Local Traffic Committee Meeting

BYRON
SHIRE
COUNCIL

MINUTES OF THE LOCAL TRAFFIC COMMITTEE MEETING HELD ON TUESDAY, 15 NOVEMBER 2022

Figure 1: Signage plan (Sleep Bus).

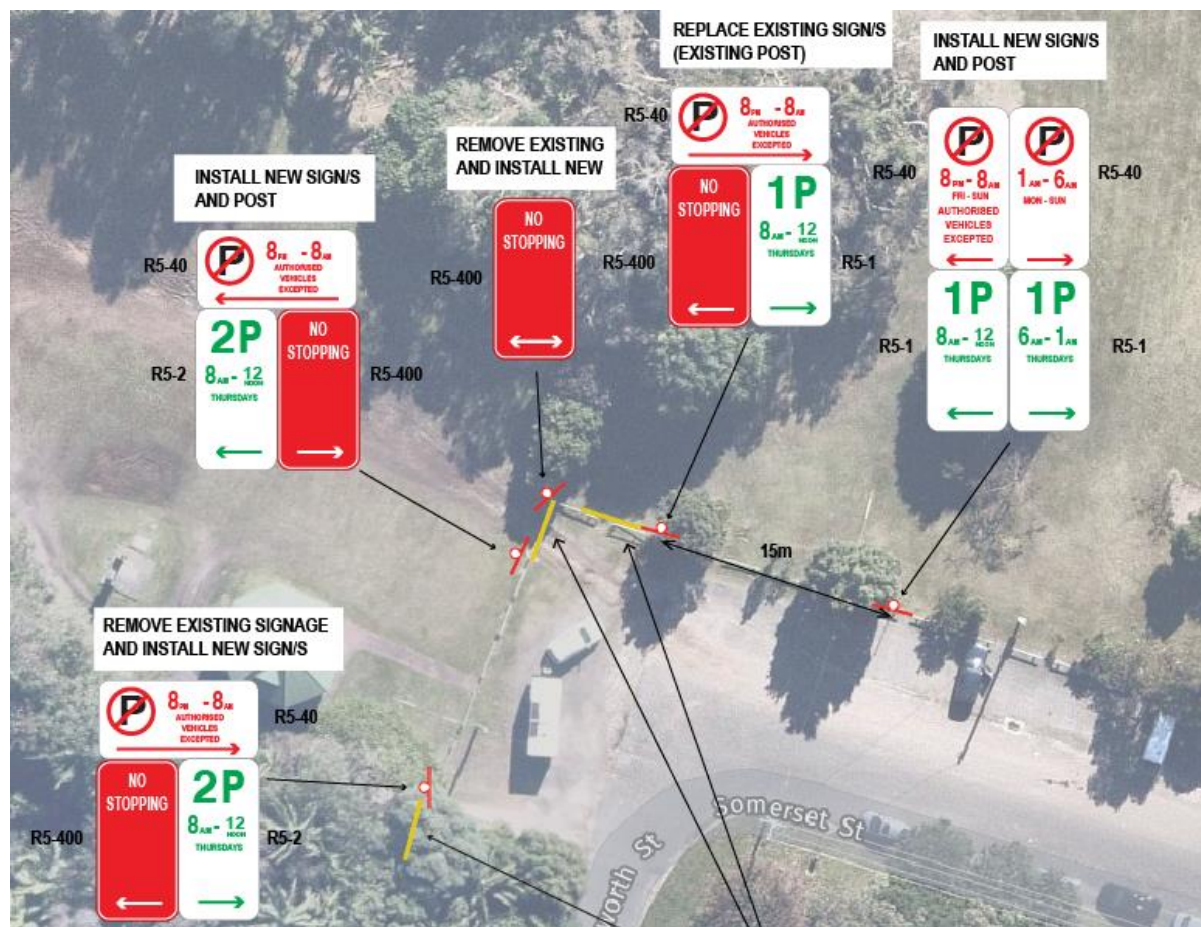
TfNSW: Have the local residents been consulted?

TfNSW: Recommend that Council separate No Stopping signage from parking signage using separate posts.

Council to advise local residents of works prior to Council meeting.

It is recommended that Local traffic Committee support the installation of the signage shown in figure 1 of report at the intersection of Somerset Street and Wordsworth Street, Byron Bay.

Figure 7: Associated works (Tincogan St/Dalley St intersection)

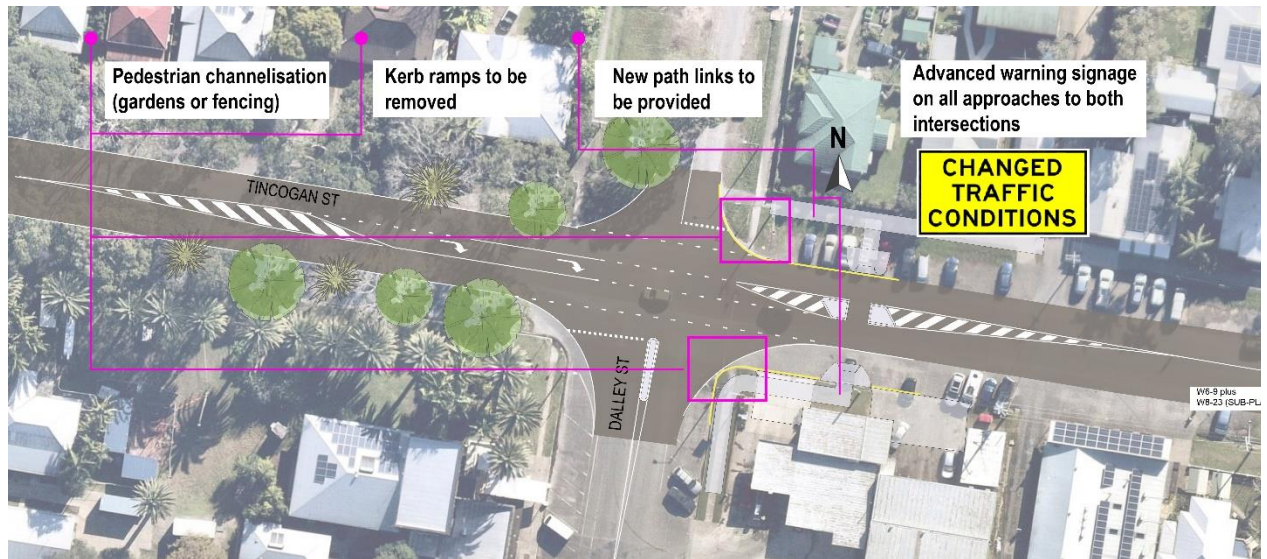
Siobhan: Request that Council consult with community in relation to MRA comments below.

Consultation to be undertaken with the Mullumbimby Residents Association, the Liberty service station and local sight impaired residents prior to implementation.
